**Grid Code
Modification
Recommendation Form**

MPID 286 Correction of Connection Voltage Graphs for 110kV and 220kV Systems under CC.7.3.6.5

MPID: 286

Date:	20 January 2021
Recommended at GCRP Meeting No.:	Ireland GCRP Meeting dated 03 November 2020
Grid Code Version:	8.1 (this modification recommendation is based on the revision of Grid Code version 8.1, that was the version of Grid Code at the time the proposal was presented to the GCRP members. The current Grid Code in effect is Grid Code version 9).
Grid Code Section(s) Impacted by Recommended Proposal:	CC.7.3.6.5

110kV Connection Voltage

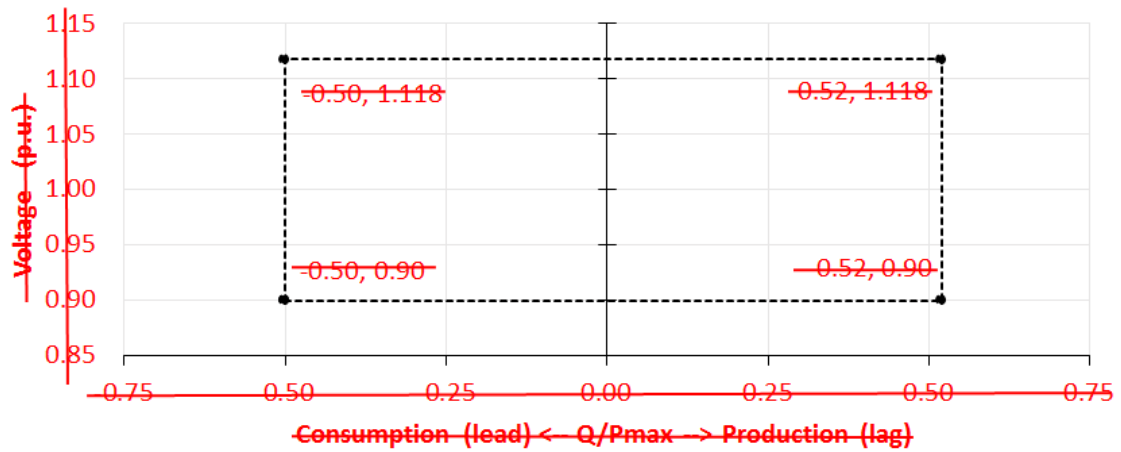
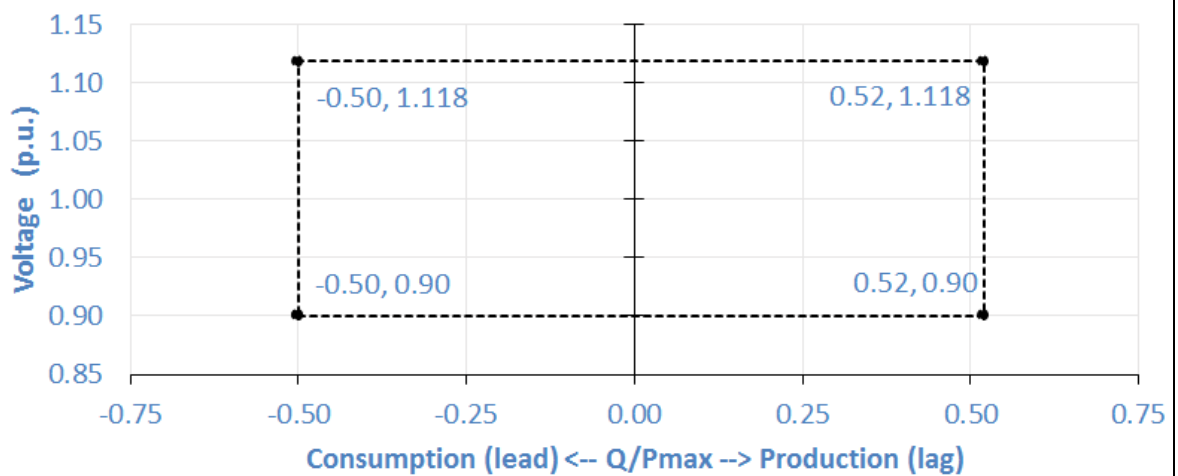
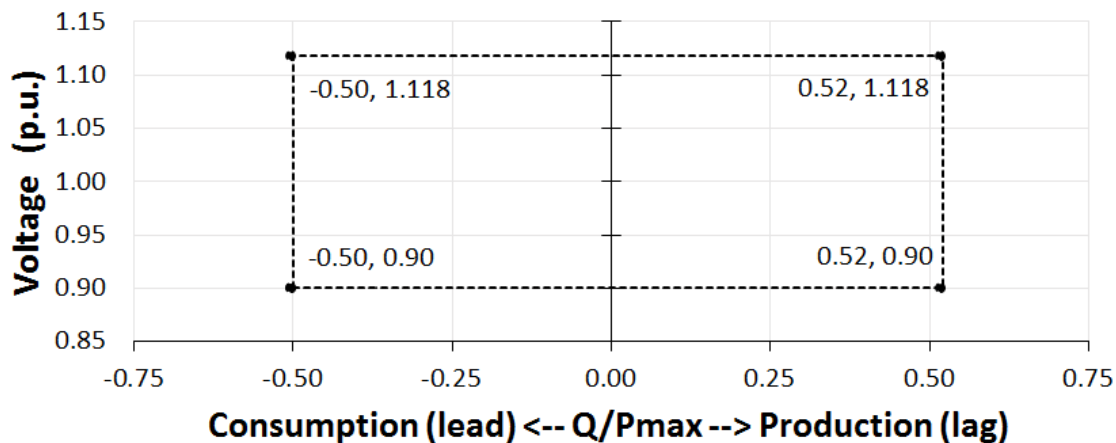
CC.7.3.6.5 shows a maximum voltage withstand capability of 1.118 p.u. for connections at 110 kV and 220 kV. In the case of 110 kV and 220 kV, this would require equipment to have the capability to continually withstand 123 kV and 246 kV respectively.

As per clause CC.8.3.2, the maximum transmission system voltages during a transmission fault for 110 kV and 220 kV are nominally 123 kV and 245 kV respectively. This equates to an upper voltage limit of 1.118 p.u. for 110 kV transmission systems and 1.114 p.u. for 220 kV transmission systems. The values in clause CC.7.3.6.5 should be aligned with the values stated in clause CC.8.3.2.

To rectify this error, we propose separating out the graphs for 110 kV and 220 kV, retaining the upper voltage limit for 110 kV systems of 1.118 p.u. and correcting the upper voltage limit for 220 kV systems to 1.114 p.u.

-110kV and 220kV Connection Voltage
